Drawing Amendments

Applic. No. 10/694,600  
Amdt. dated March 28, 2005  
Reply to Office action of December 28, 2004

Fig. 1

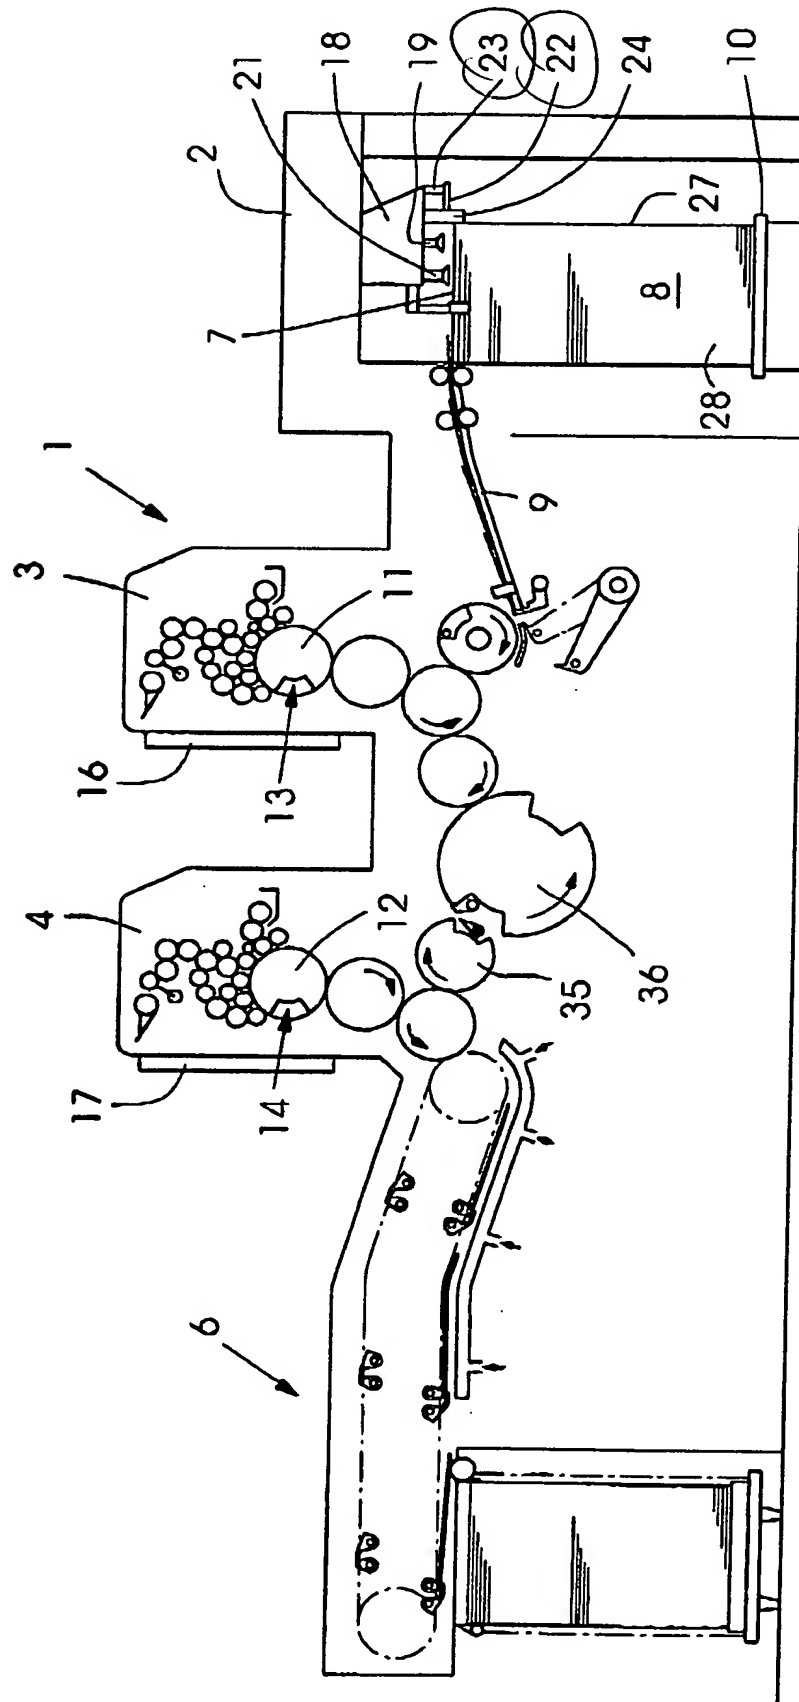
In item 1 on page 2 of the above-identified Office action, the drawings have been objected to under 37 CFR 1.84(p)(4).

The Examiner stated that the reference characters "22" and "23" are used to designate the same part. The drawings have been changed as noted above so as to facilitate prosecution of the application. Therefore, the objection to the drawings by the Examiner is believed to have been overcome.

The Examiner stated that "blowing devices 22" should be --blowing device 22-- and "sensing elements 23" should be --sensing element 23--. Applicants respectfully disagree with the Examiner. Fig. 1 is a two dimensional diagrammatic view of a printing press. The leaders indicating these items point to the side of the elements and sufficiently support the fact that there is a plurality of the items. This does not require

The attached sheet of drawings includes changes to Fig. 1. This sheet which includes Fig. 1, replaces the original sheet including Fig. 1. In Fig. 1, previously references characters "22" and "23" were changed so as not to designate the same part.

Please approve the drawing changes that are marked in red on the accompanying "Annotated Sheet Showing Changes" of Fig. 1. A formal "Replacement Sheet" of amended Fig. 1 is also enclosed.

any further clarification in the specification. Therefore, the specification has not been amended to overcome the objection by the Examiner.
